LINCOLN CITY/LANCASTER COUNTY PLANNING STAFF REPORT

P.A.S.: Vintage Heights 3rd Addition **DATE:** November 14, 2002
Annexation #02009
Change of Zone #3374
Special Permit #1762A
Preliminary Plat #02017

PROPOSAL: To annex 7.1 acres, preliminary plat 182 lots and amend the special permit for 946 dwelling units and expand the boundaries of the special permit to include the area of the preliminary plat.

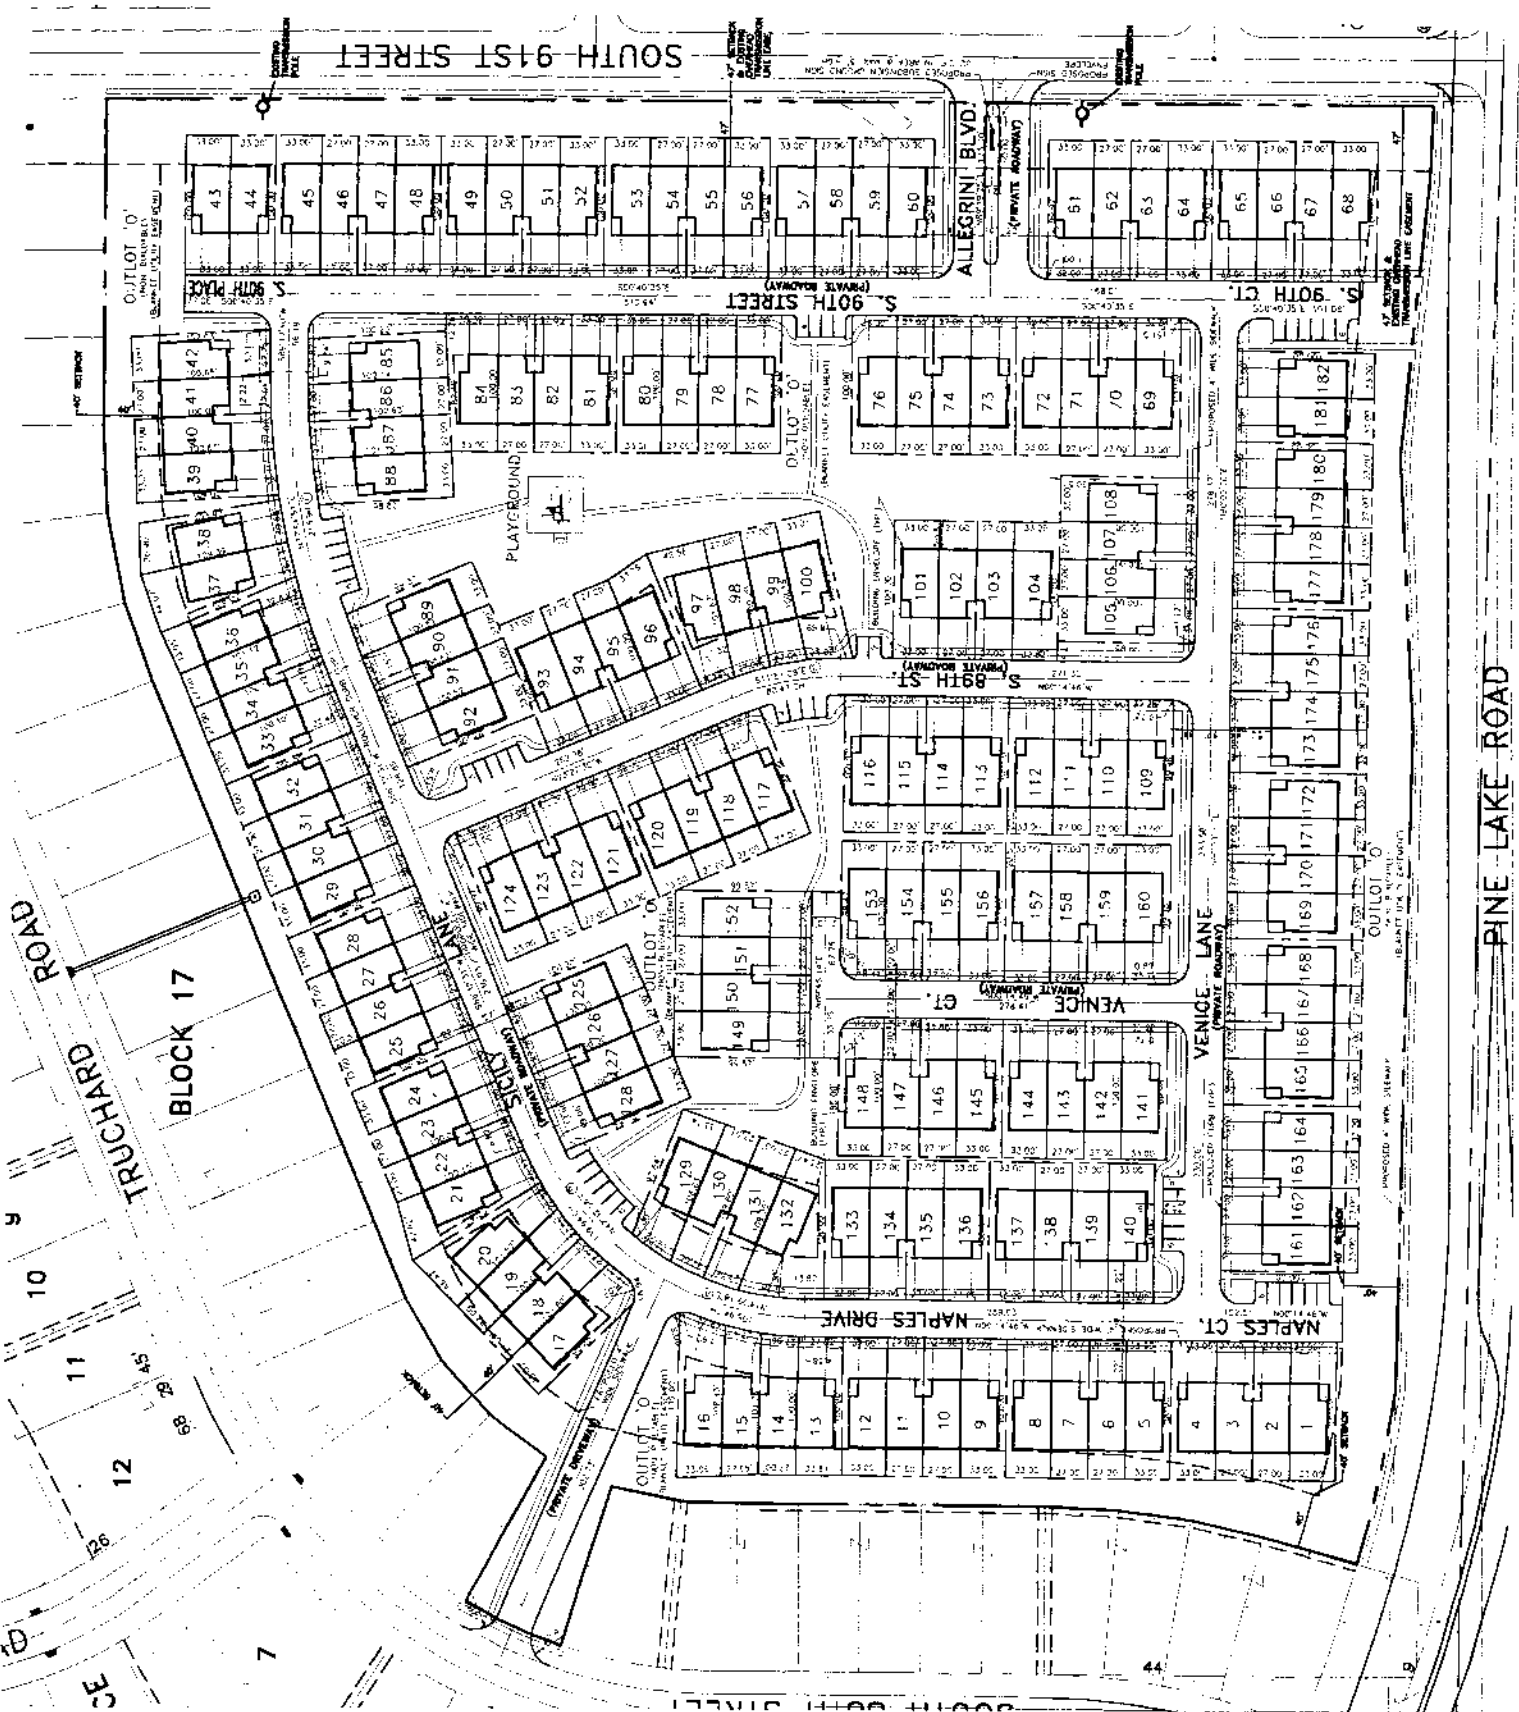
3. The Public Works & Utilities Department had the following comments:
 - a. Sanitary sewer and water mains are satisfactory. The revisions to the drainage and grading plan raise an additional concern, the sanitary sewer in the northeast corner of the plat between 90th and 91st Street. The location is shown at the bottom of a drainage ditch with the required easement on the steep side slopes. This is unsatisfactory and a specific 30' easement is required for this sewer. The blanket easement is unsatisfactory.

- b. The plan still shows drainage flowing from the edge of pavement to the property line rather than the property line to the pavement along Pine Lake Road as required by design standards.

- c. The grading information provided in the NE corner of the plat is unsatisfactory. The plan shows grading a 30' wide swale over the storm sewer in the 91st Street right-of-way. Grading and sidewalk grades in S 91st Street will not be altered. Without the regrading of the right-of-way, it appears that lots to the north will be flooded in the 100 year event. This is unsatisfactory.

- d. Design standards require low flow liners or other means to provide a stable grade or hardened bottom along open drainage channels. None are shown. The bottom of the proposed channel along the north side of the plat is adjacent to platted lots. These lots should be protected up to a 100 year storm. Opening elevations for houses must be shown for lots adjacent to the open drainage channels.

- e. Public Works & Utilities Department still recommends the private driveway east of S. 88th Street be built as a private roadway. Block length requirements as well as potential traffic numbers require a private roadway with Public Works indicating there will not be a median opening in Pine Lake Road at S. 91st Street. More traffic from the townhouse area will use S. 88th Street.

- f. The north-south portion of Venice Court as it intersects the east-west portion is in violation of the platform requirement and must be revised. Venice Court does not have a permanent turn around as per subdivision ordinance requirements.

- 4. The application is in conformance with the 2025 Comprehensive Plan and the Southeast Subarea Plan.
 - 5. A sidewalk connection S. 90th Place to S. 91st Street should be provided for maximum mobility and access. Sidewalks on all sides of public streets and private roadways must also be provided for mobility and access. The applicant requested a waiver to sidewalks on one side of Venice Court. This is not in conformance with the 2025 Comprehensive Plan or the Subdivision Ordinance and should be revised to comply.

- 1.1 Revise the preliminary plat to show:
 - 1.1.1 Block 17(Sheet 1 and 2 of 11) consistent with the larger site plan for Allegrini Terrace(Sheet 1 of 6).

- 1.1.2 Revise the grading and drainage plan to meet design standards.
 - 1.1.3 A 30' sewer easement to meet design standards.
 - 1.1.4 The minimum building opening elevations for lots adjacent to open drainage channels must be above the elevation of a 100 year storm.

- 1.1.5 Low flow liners to meet design standards.
 - 1.1.6 The private driveway east of S. 88th Street shown as a private roadway. The private roadway must be named.

- 1.1.7 Platforms for the north-south portion of Venice Court as it intersects the east-west portion in conformance with the Subdivision Ordinance to the satisfaction of the Public Works & Utilities Department.

- 1.1.8 Venice Court with a permanent turn around in conformance with the Subdivision Ordinance.
 - 1.1.9 Sidewalks on both sides of all streets and private roadways, including the south side and west and east ends of the turnaround of Venice Court.

- 1.1.10 A sidewalk connection from S. 90th Place to S 91st Street north of Lot 43, Block 17.
- 1.1.11 Landscaping between lots backing onto S. 91st Street to meet design standards for lots backing onto major streets and a note on the site plan indicating that on Lots 43-68 and 209, Block 17 stockade fences are not allowed.
- 1.1.12 The building envelope on Lot 140, Block 17 located 10' from 5' wide sidewalk easement to the south to comply with §27.71.230.
